20-016 Walthamstow Care Sites - Hurst Road
Design and Access Statement - Addendum v3
July 2023; updated August 2023; updated September 2023

This Addendum supercedes the relevant sheets of the submitted Design and Access Statement and summarises the amendments made through discussions with LBWF since January 2022.

5.5 Safety and Security - addendum

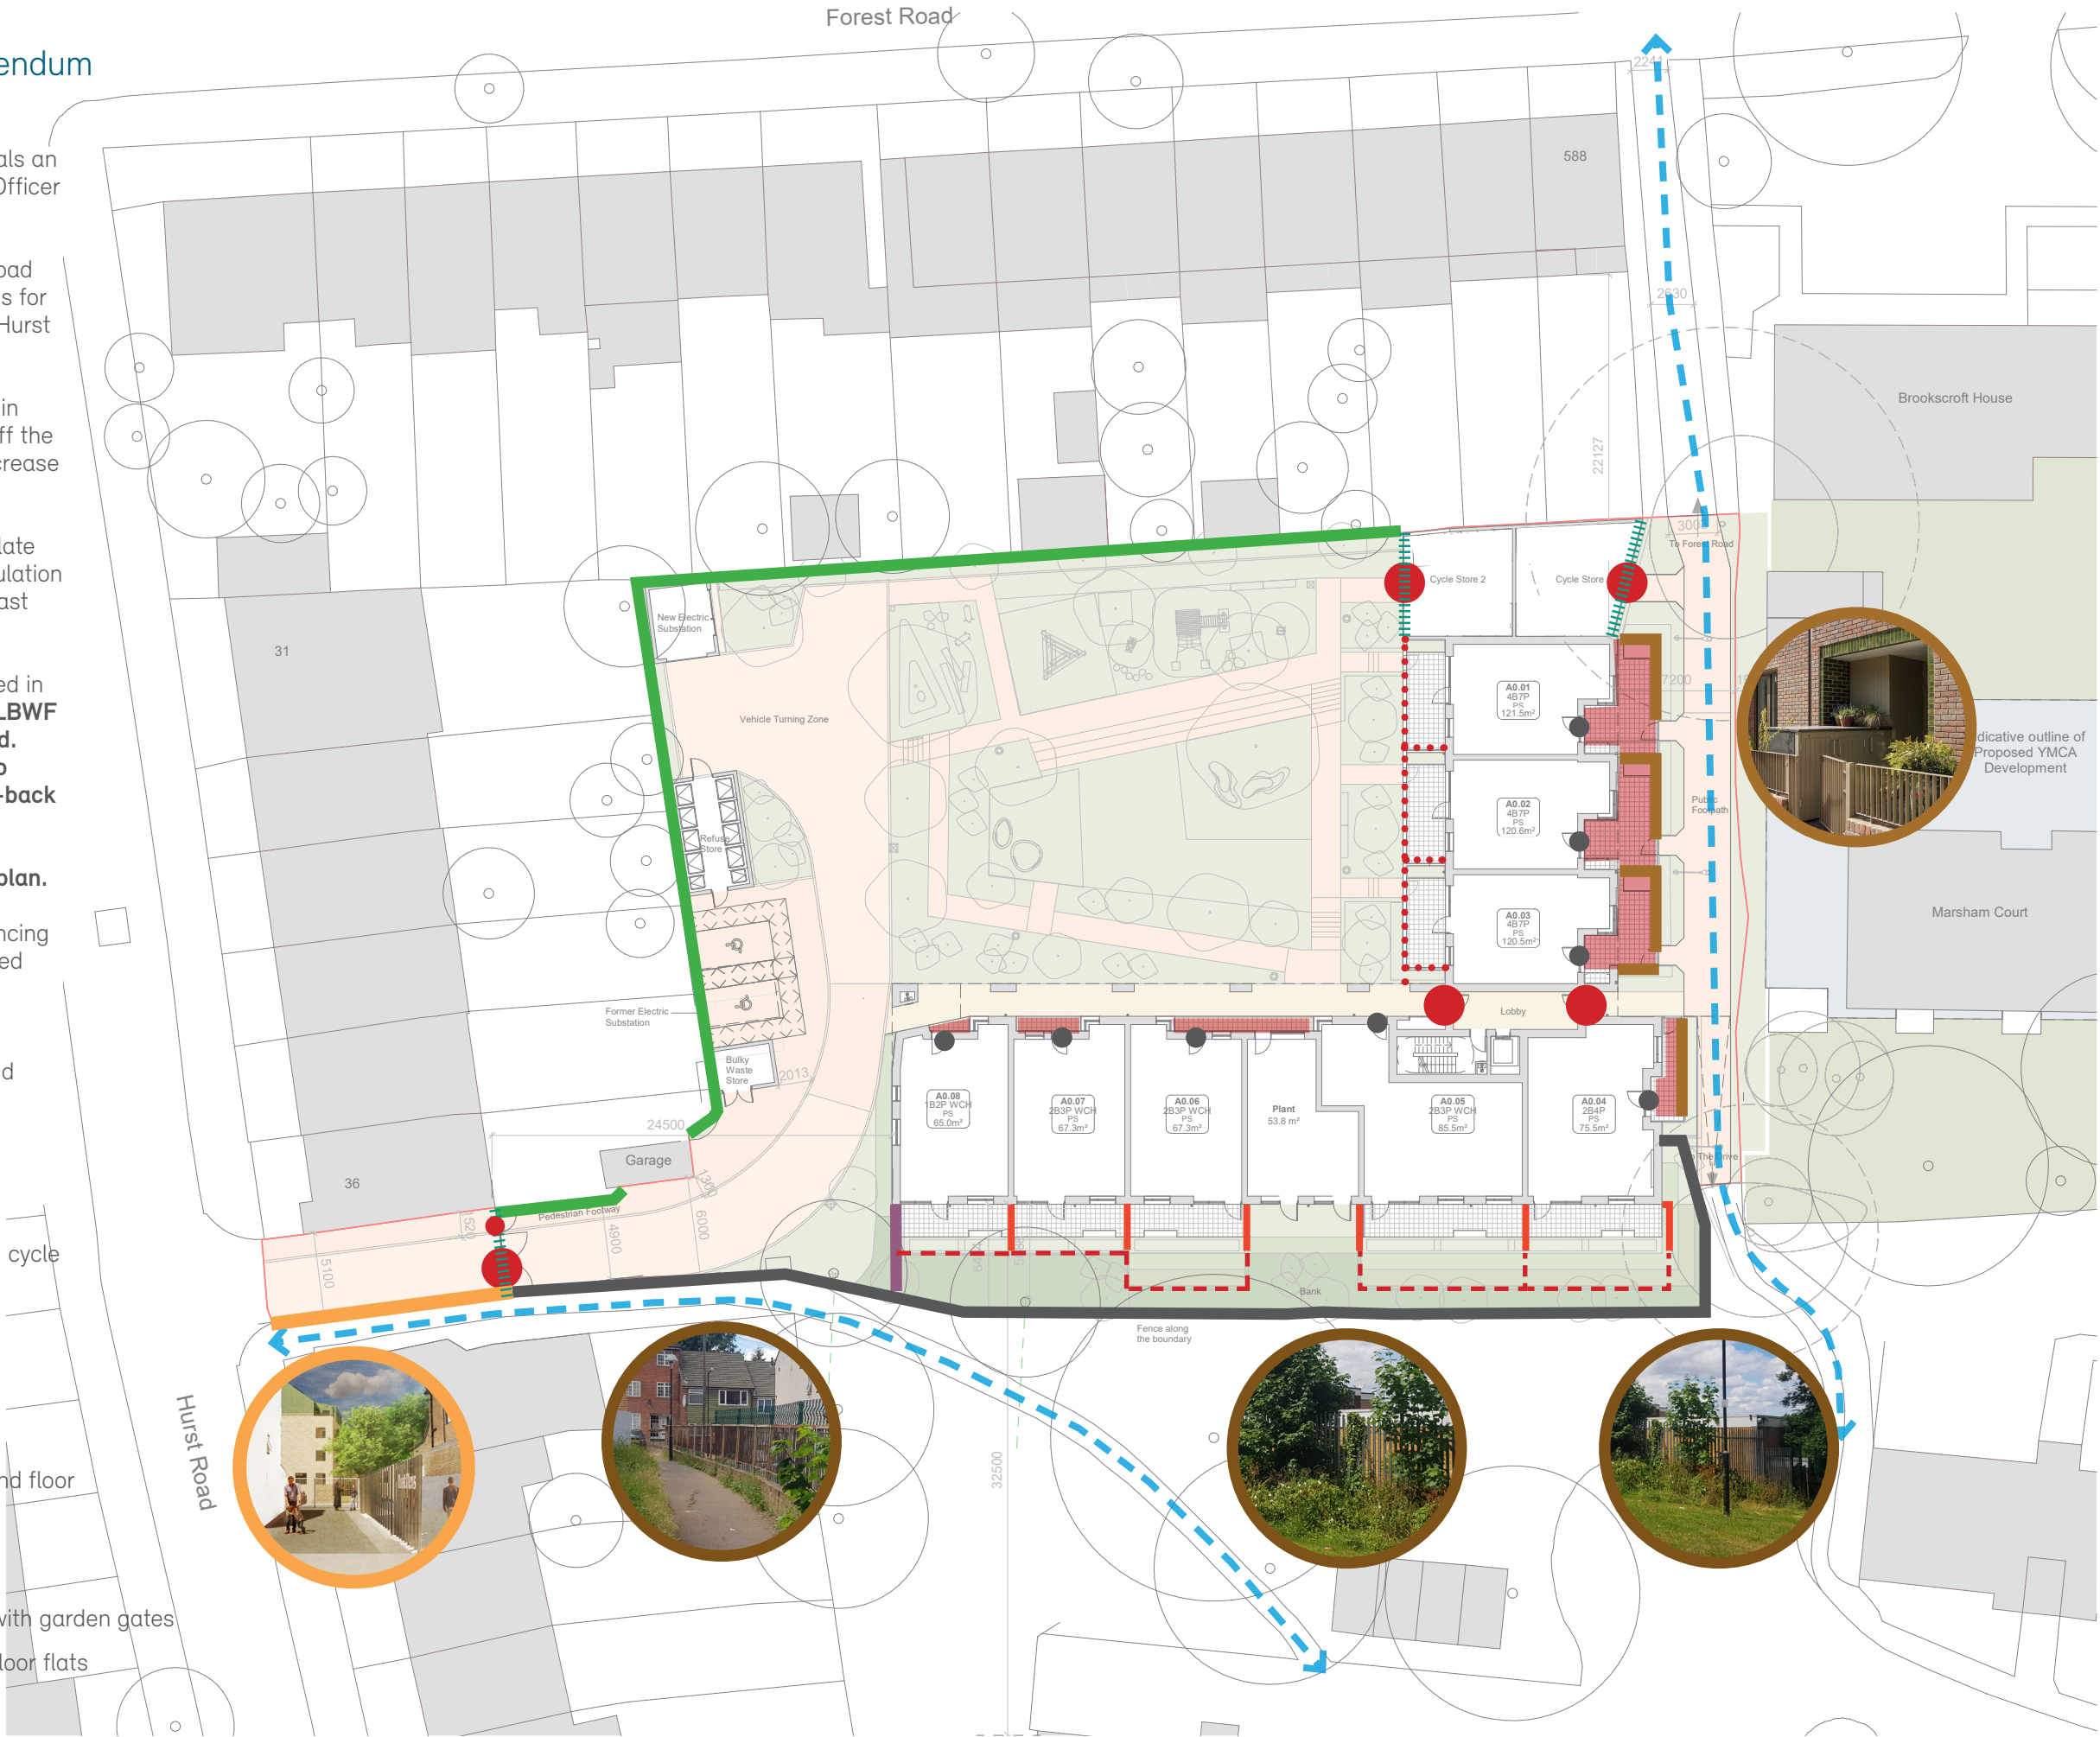
Following DOCO feedback the cycle storage was located in northeast, accessible from the footpath only. **Update: LBWF planners requested access also from within courtyard. To ensure no unauthorised access via cycle store into courtyard the cycle storage is divided into 2 back-to-back stores maintaining the policy compliant 68 spaces.**

Update: details of boundaries indicated on adjacent plan.
